# FIRE SAFETY INSPECTION REPORT

## Dewan Fashion Wears Ltd. (Relocated)

Factory ID: 24710

Date: 9 July 2023

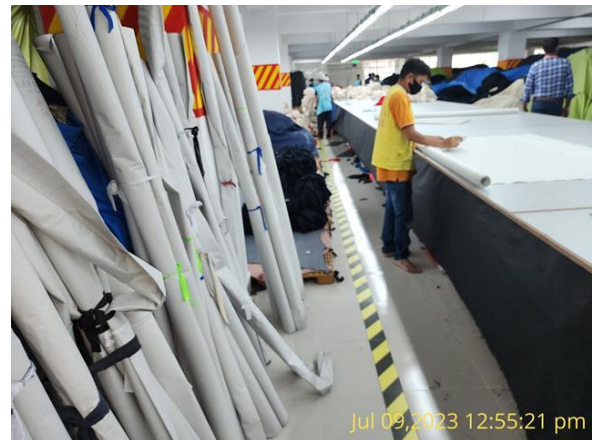
| F-17 | Egress | Handrails height was below 30 inches. | Provide handrails on both sides of the exit stair. New handrails shall have a minimum height of 865 mm (34 in.) and a maximum height of 965 mm (38 in.) as measured from the leading edge of the tread. Intermediate handrails shall be provided when the stair width exceeds 2.2 m (87 in.) | Within 3 months |
